County of Los Alamos

Agenda - Final Planning and Zoning Commission

PLANNING & ZONING COMMISSION STAFF REPORT

Public Hearing Date: August 12, 2026
Subject: Case No. SIT-2026-0083
Applicant/Owner: Christus Health
Case Manager: Danyelle Valdez, Planning Manager

MASTER UTILITY PLAN
SCALE: 1" = 20'

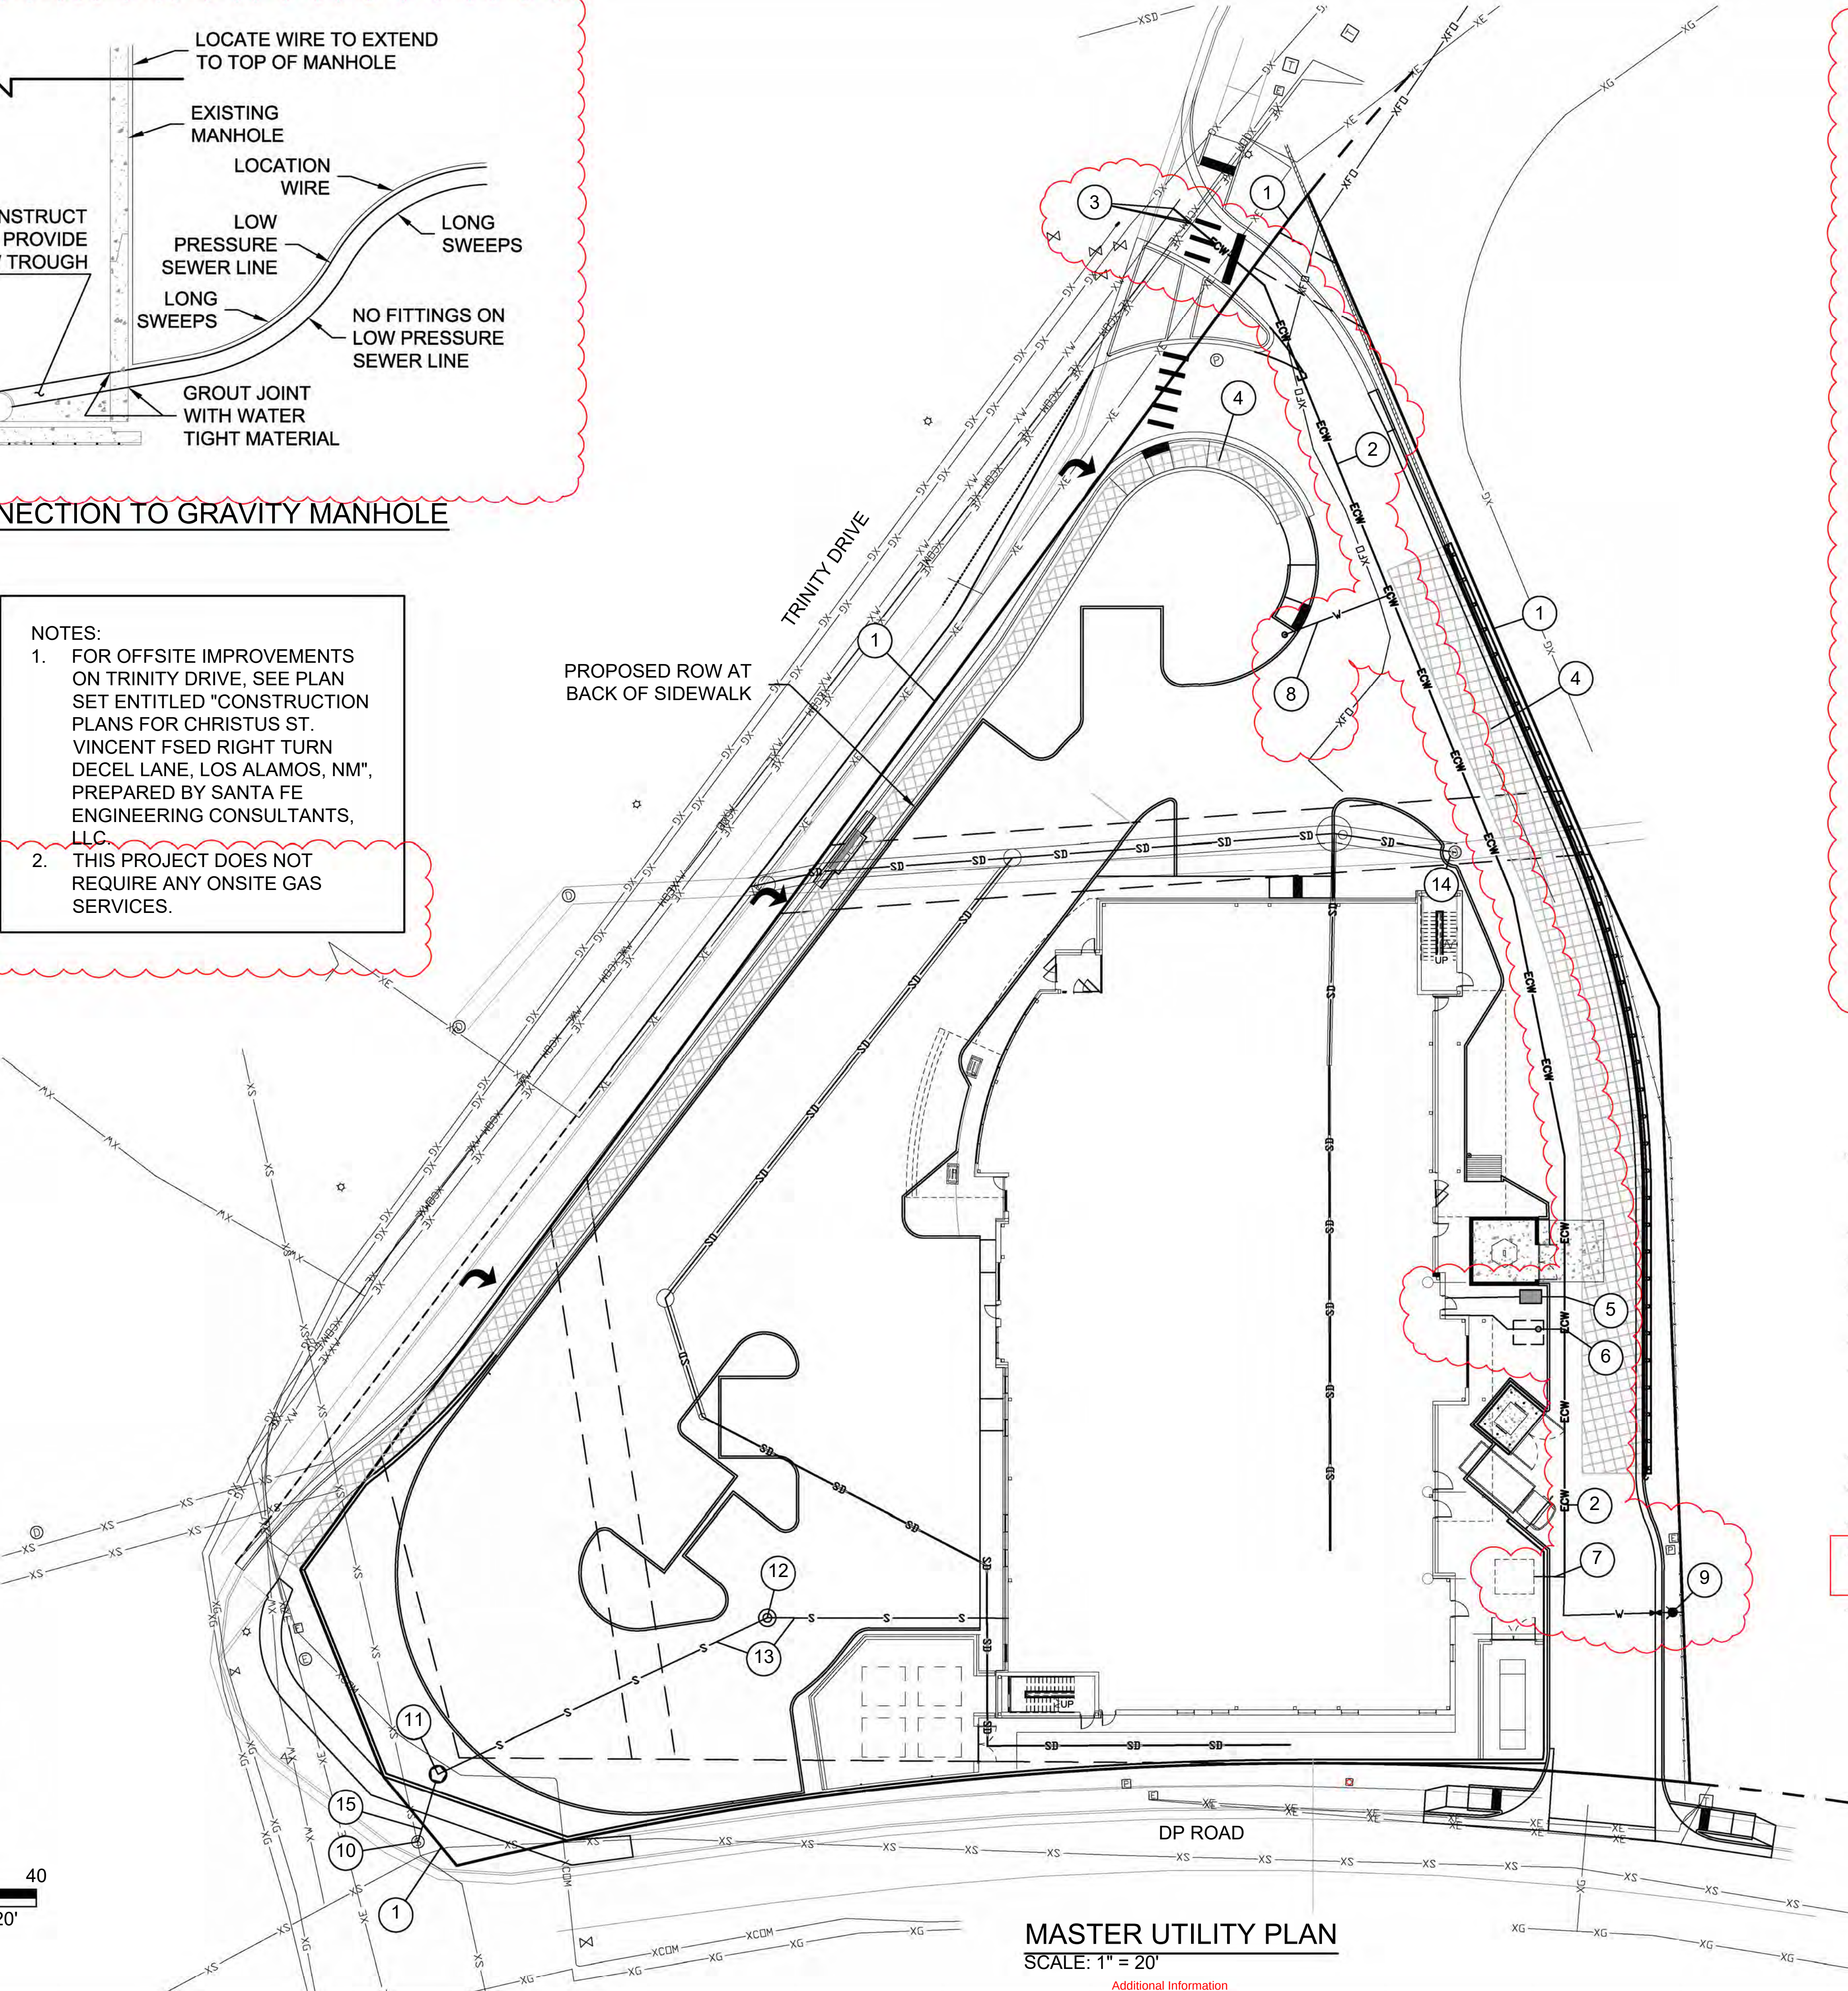
DPU reviewed the site plan application and provided technical comments and conditions applicable to the permit documents. The applicant must provide a joint utility trench cross-section showing an approved staggered layout consistent with the applicable DPU Construction Standards Drawing; identify the proposed gas-line size and physical location of the gas meter; revise the fire hydrant and hydrant-leg details to conform to the applicable Los Alamos County standard detail; and provide a connection detail for the existing sewer manhole.

1. Prior to submitting any associated permit applications, the applicant shall revise the applicable drawing sheets to: (1) provide a joint utility trench cross-section showing an approved staggered layout consistent with the applicable Department of Public Utilities Construction Standards Drawing; (2) identify the size of the proposed gas line and the physical location of the gas meter; (3) revise the fire hydrant and hydrant-leg details to conform to the applicable Los Alamos County standard detail; and (4) provide a connection detail for the existing sewer manhole. The corrected drawing sheets shall be submitted directly to the Department of Public Utilities for final review and verification.

The corrected drawing sheets must be submitted directly to DPU for final verification before the associated permit applications are submitted. Conditions of approval have been added.

SECTION D105
AERIAL FIRE APPARATUS ACCESS ROADS

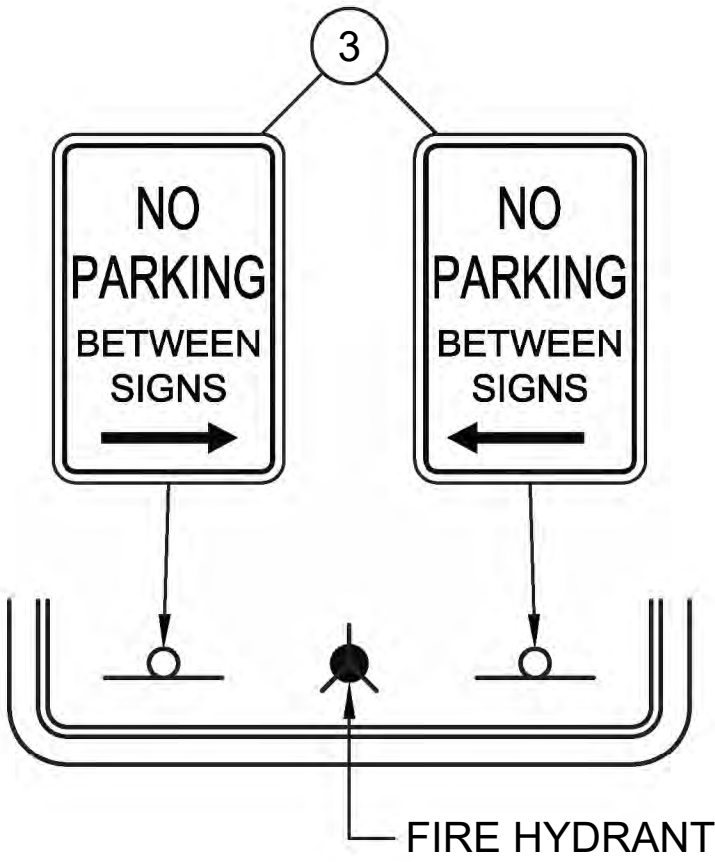
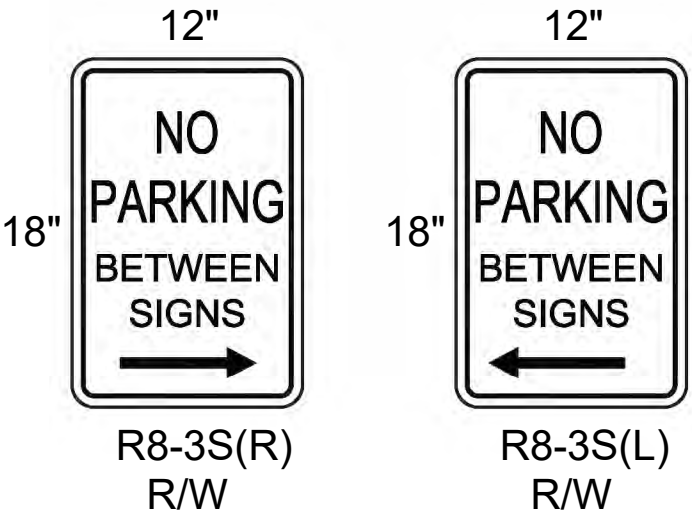
The Los Alamos County Fire Marshal initially requested that the plans clearly identify the fire apparatus access road and demonstrate compliance with applicable International Fire Code requirements, including minimum unobstructed widths, access to all portions of the building, apparatus turning radii, hose-access distances, hydrant and fire department connection locations, and the location of the post indicator valve.

2. Prior to submitting any associated permit applications, the applicant shall revise the plans to address Fire Marshal requirements, including citation of the currently adopted 2021 International Fire Code; provision of compliant aerial fire apparatus access or, where approved by the Fire Code Official, a Class I standpipe meeting the exception to IFC Section D105.1; and relocation or addition of a fire hydrant to provide adequate coverage at the north entrance. Revised plans shall be submitted to the Fire Marshal for final review and approval.

The applicant submitted revised drawings on July 31, 2026, addressing fire apparatus access and hydrant placement. These items are reflected in the Conditions of Approval included in this staff report.

DUMPSTER ENCLOSURE DETAILS

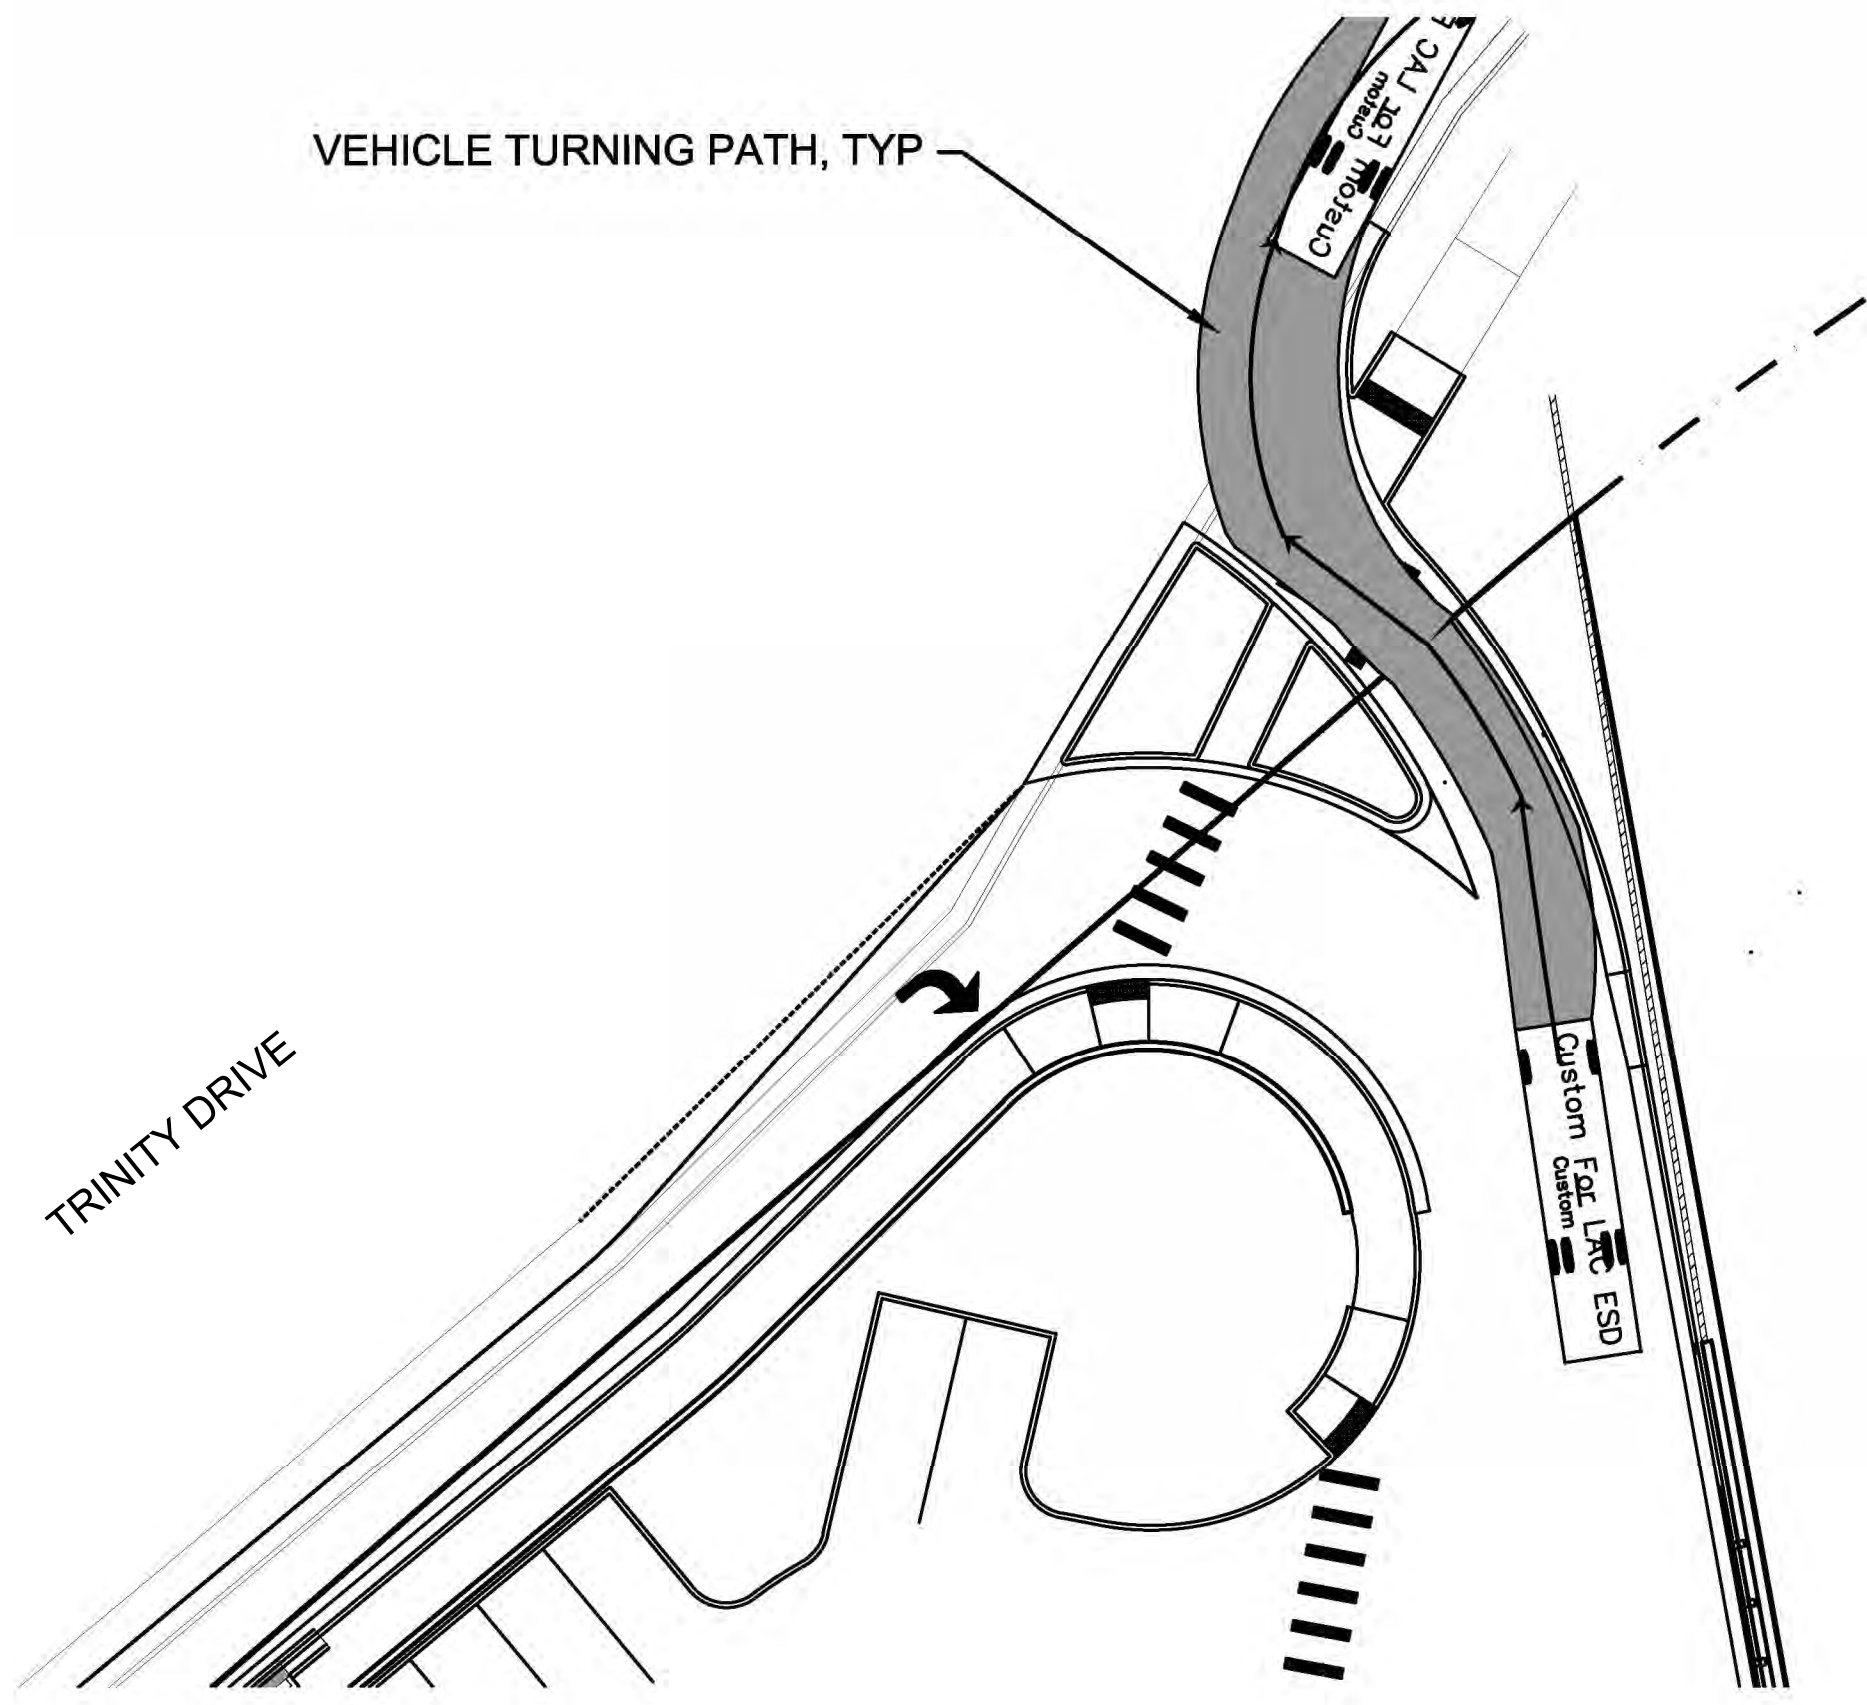
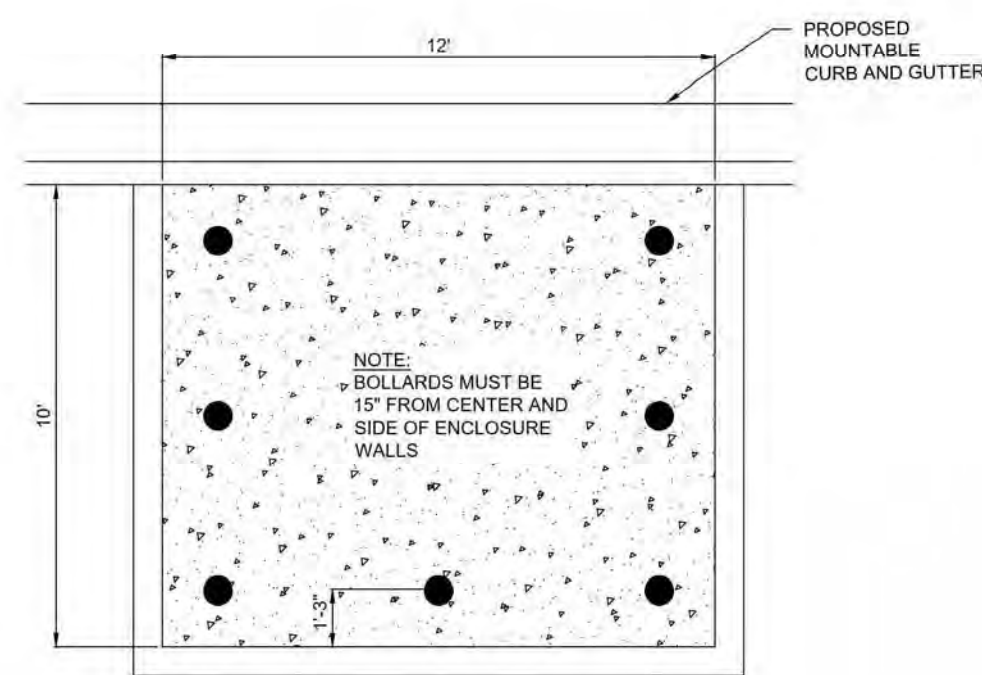
Environmental Services requested revised plans identifying the location of all refuse and recycling receptacles and demonstrated adequate access and egress for collection vehicles. Environmental Services initially requested locating the collection area within the alley behind AutoZone, with vehicles entering from Trinity Drive and exiting onto DP Road to establish a one-way circulation pattern aligned with the facility loading dock.

The applicant submitted revised drawings on July 31, 2026, showing the dumpster enclosure, collection location, and vehicle turning movements. Environmental Services reviewed and accepted the revised drawings that include locating the collection area along the eastern portion of the subject property to align with the proposed driveway access from DP Rd.
